Access Compliance Report Public Rights-of-Way (Curb Ramps)

Intersection ID: 50523 Main Street: SHEFFINGDELL_DR Cross Street: JASMIN_MAY_DR Location: N

ADA ID: 0CD2C0C7FC98 Ramp Type: PerpDiag Initial Pass/Fail: Fail Overall Compliance: No Severity Score: 33.75

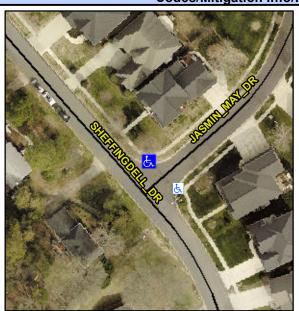
Not Found, R304.5.1, R304.2.2, R304.5.3

Field Measurements/Component Compliance					
Compliance Description		Data	Comp	liance Description	Data
N/A	Ramp Length (in)	72.0	No	Ramp Slope (%)	9.4
No	Ramp Width (in)	39.0	No	Ramp XSlope (%)	6.3
N/A	Flare Type LT	N/A	N/A	Flare Type RT	N/A
N/A	Flare Slope LT (%)	N/A	N/A	Flare Slope RT (%)	N/A
N/A	Flare Traversable LT?	N/A	N/A	Flare Traversable RT?	N/A
N/A	Landing Length (in)	N/A	N/A	DWS Provided?	N/A
N/A	Landing Width (in)	N/A	N/A	DWS Contrast?	N/A
N/A	Landing Slope (%)	N/A	N/A	DWS Length (in)	N/A
N/A	Landing X Slope (%)	N/A	N/A	DWS Full Width?	N/A
N/A	Landing Curb? (Y/N)	N/A	N/A	DWS Offset (in)	N/A
N/A	Shared Landing?	N/A			
N/A	Gutter Ponding?	N/A	N/A	Gutter Slope (%)	N/A
N/A	Gutter Lip Ht (in)	N/A	N/A	Gutter X Slope (%)	N/A
N/A	Painted X Walk1?	No	N/A	Painted X Walk2?	No
	X Walk 1 Direction	To SW		X Walk 2 Direction	To SE
N/A	X Walk 1 Width (in)	N/A	N/A	X Walk 2 Width (in)	N/A
	X Walk 1 Slope (%)	2.2		X Walk 2 Slope (%)	4.4

Remove & Replace Curb Ramp With Two New Directional Ramps or Equivalent.
